01 - 2010
BDF453 / BDF453Z / BDF453H
18V 1/2" DRIVER DRILL

SERVICE CHANGES

1. Changes on Switch, Terminal, and Housing Set (Battery Protection Circuit)

(T/I# 93856)

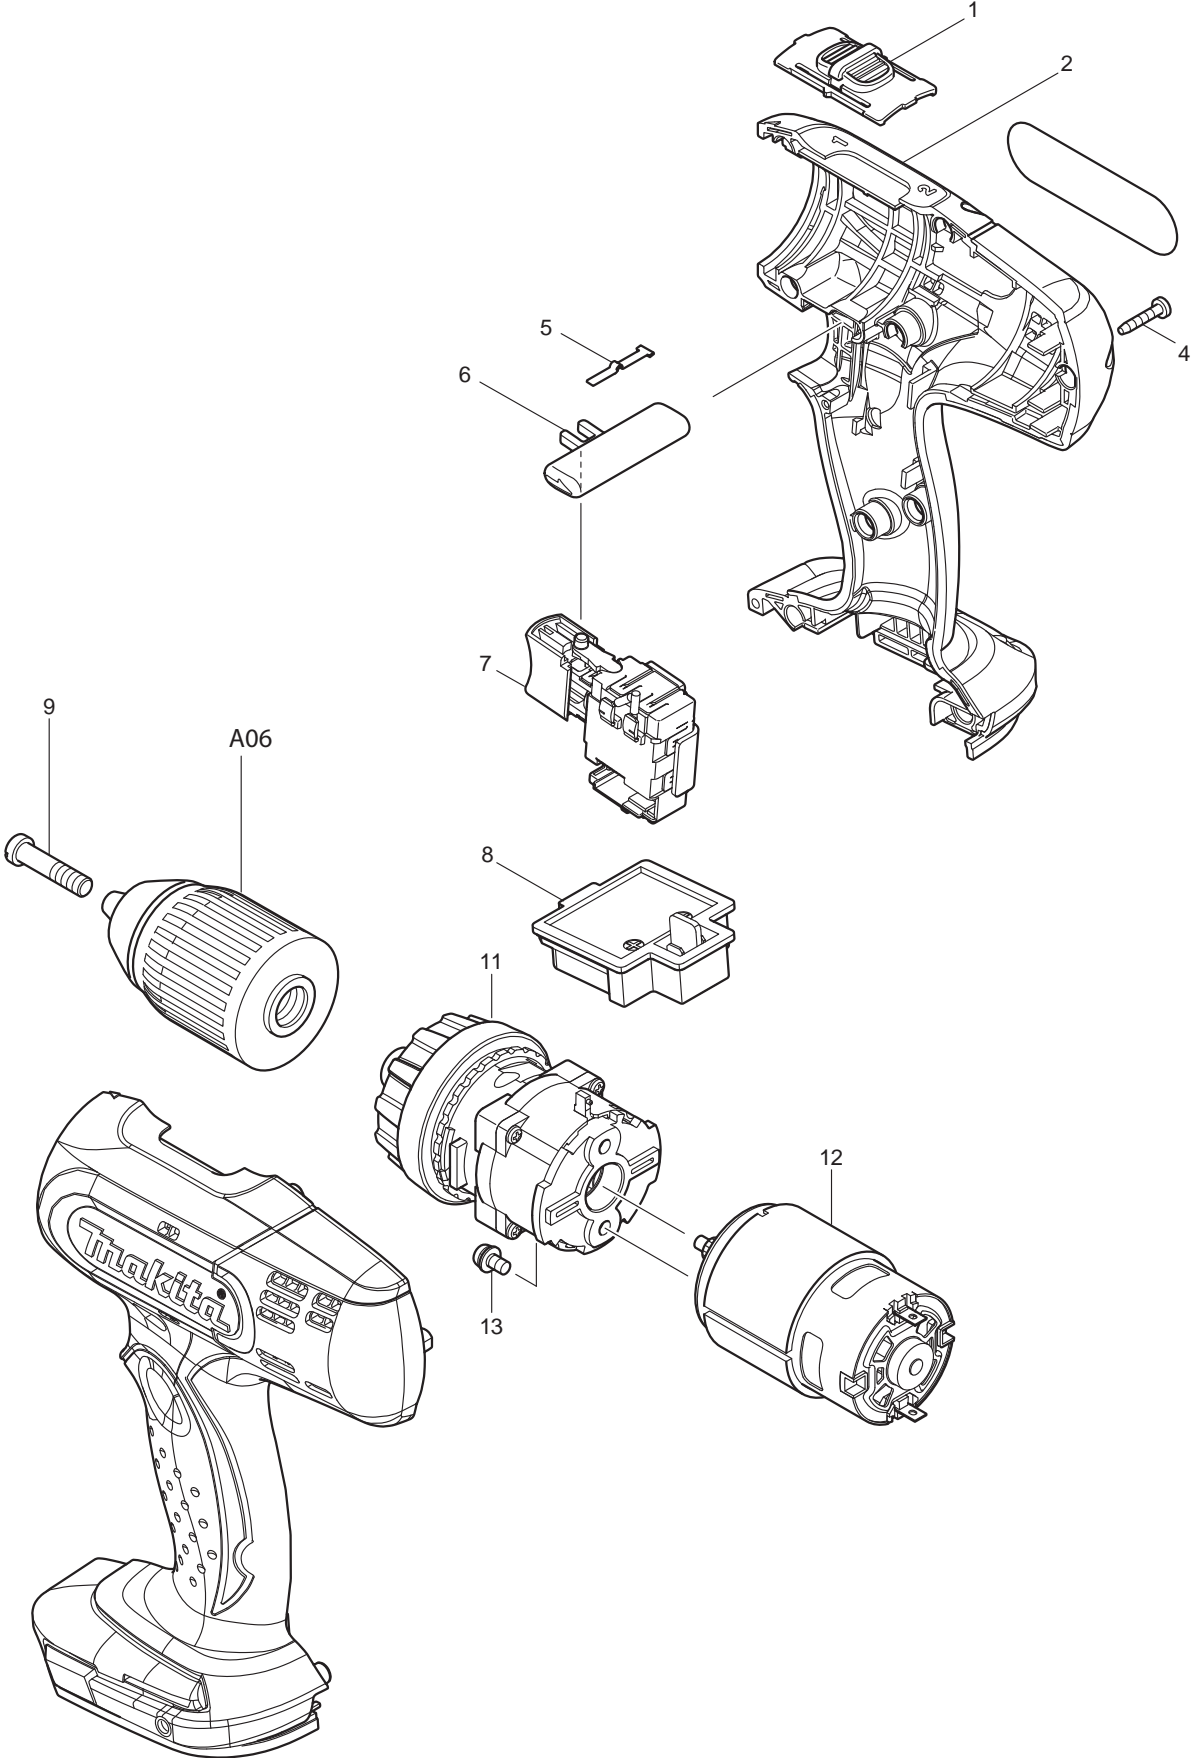
Item No.	Description	Type 1	Type 2	Type 3
2	HOUSING SET		188542-5	187363-2
7	SWITCH		650604-4	632A24-0
8	TERMINAL	643812-4	643844-1	643852-2

Above parts are completely interchangeable as a set.

- Use new parts for repair of the model manufactured on or after December 2011 with using Yellow lead wire between Switch and Terminal.
- Use current parts for repair of the model manufactured before December 2011 without using Yellow lead wire between Switch and Terminal.

*** See Technical Information No. 93856 for Wiring changes.**
